Charlotte Department of Transportation

Memorandum

Subject: Rezoning Petition 15-001: Approximately 3.63 acres located on the east side of North Davidson Street and bounded by East 27th Street, Yadkin Avenue, East 26th Street, and North Davidson Street.

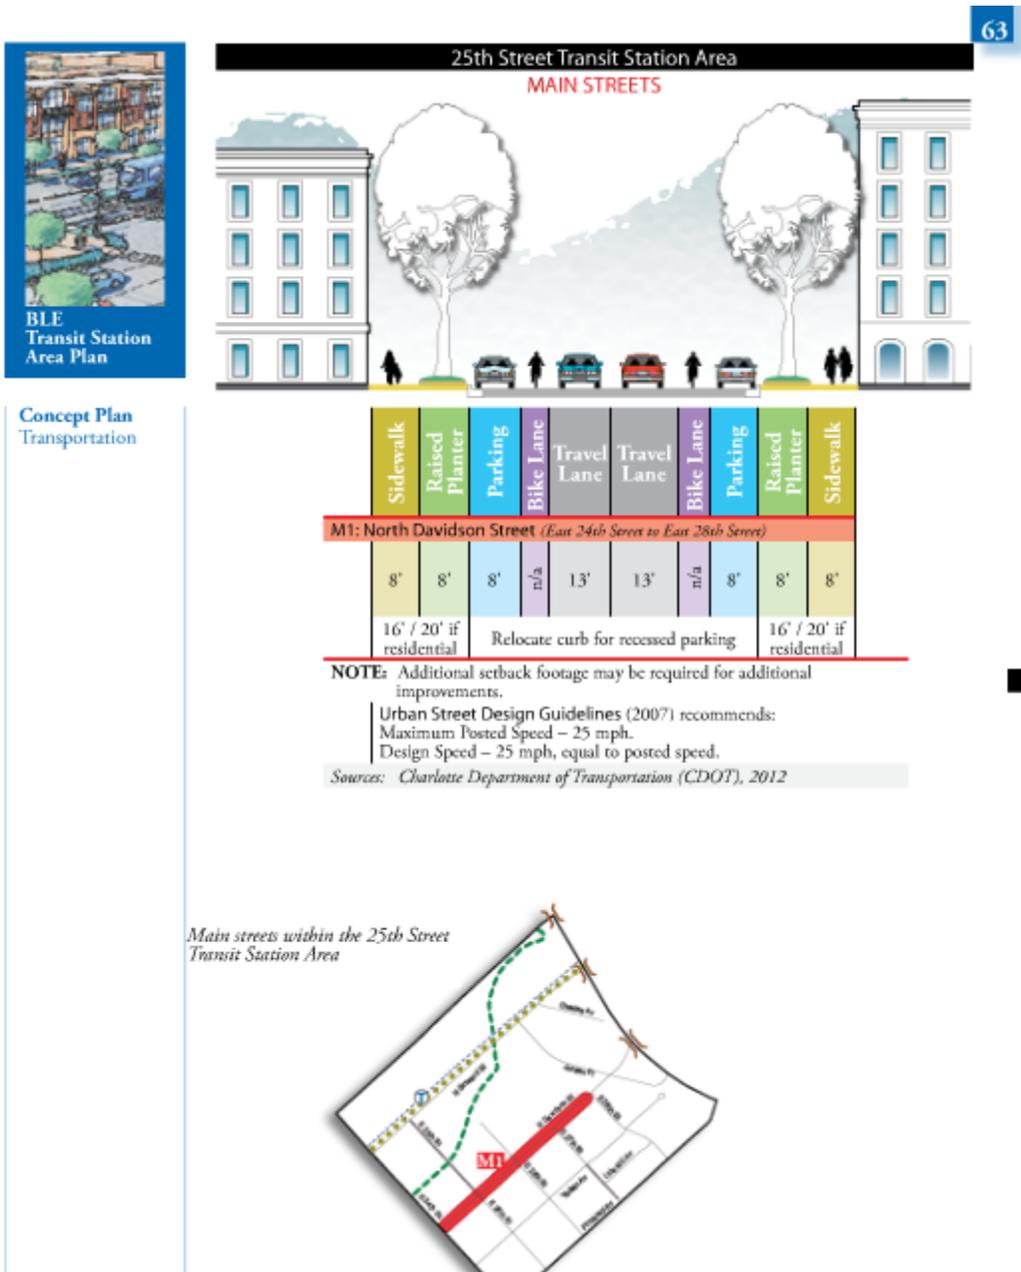
- a. *North Davidson Street* – Designated as a Main Street in the adopted transit plan (see recommended cross-section below). It appears the existing curb line can remain as is which will allow for a northbound Davidson 12' travel lane and 7' parking lane in the future. Existing bike lanes are marked and needed in the near term, in the future the bike lanes along North Davidson will be converted to on-street parking lane along the site's Davidson frontage.
